Access Compliance Report

Public Rights-of-Way

(Curb Ramps)

Intersection ID: 51582	Main Street: QUIVERING_OAK_LN	Cross Street: WESLEY_VILLAGE_RD	Location: NE
ADA ID: 582C8633ABFF	Ramp Type: Perp	Initial Pass/Fail: Fail	Overall Compliance: No
Severity Score: 8.75			
Codes/Mitigation Info/Possible Solution		Field Measurements/Component Compliance

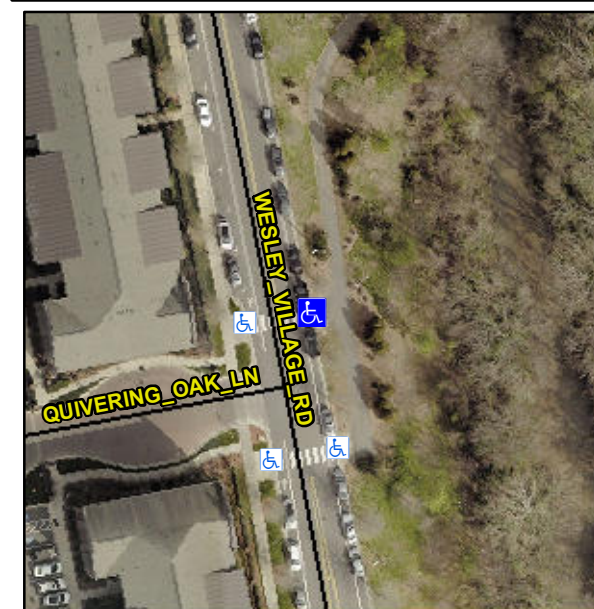
Not Found, R304.5.1

Compliance	Description	Data	Compliance	Description	Data
N/A	Ramp Length (in)	74.5	Yes	Ramp Slope (%)	6.0
No	Ramp Width (in)	47.5	Yes	Ramp XSlope (%)	1.3
N/A	Flare Type LT	N/A	N/A	Flare Type RT	N/A
N/A	Flare Slope LT (%)	N/A	N/A	Flare Slope RT (%)	N/A
N/A	Flare Traversable LT?	N/A	N/A	Flare Traversable RT?	N/A
N/A	Landing Length (in)	N/A	N/A	DWS Provided?	N/A
N/A	Landing Width (in)	N/A	N/A	DWS Contrast?	N/A
N/A	Landing Slope (%)	N/A	N/A	DWS Length (in)	N/A
N/A	Landing X Slope (%)	N/A	N/A	DWS Full Width?	N/A
N/A	Landing Curb? (Y/N)	N/A	N/A	DWS Offset (in)	N/A
N/A	Shared Landing?	N/A			
N/A	Gutter Ponding?	N/A	N/A	Gutter Slope (%)	N/A
N/A	Gutter Lip Ht (in)	N/A	N/A	Gutter X Slope (%)	N/A
N/A	Painted X Walk1?	Yes	N/A	Painted X Walk2?	N/A
	X Walk 1 Direction	To W		X Walk 2 Direction	N/A
N/A	X Walk 1 Width (in)	96.0	N/A	X Walk 2 Width (in)	N/A
	X Walk 1 Slope (%)	1.0		X Walk 2 Slope (%)	N/A
	X Walk 1 X Slope (%)	1.0		X Walk 2 X Slope (%)	N/A

N/A	Ramp inside XWalk1?	Yes	N/A	Ramp inside XWalk2?	N/A
	Road Slope (%)	N/A	N/A	Clear Space?	N/A
	Road X Slope (%)	N/A	N/A	Clear Space to XWalk (in)	N/A
N/A	Any Obstructions?	N/A	N/A	Storm Grate/Utility Hazard?	N/A
	Obstruction Type			Storm Grate/Utility Type	
		N/A			N/A
			Yes	Surface Condition? (G/P)	Good

Remove & Replace Entire Ramp.
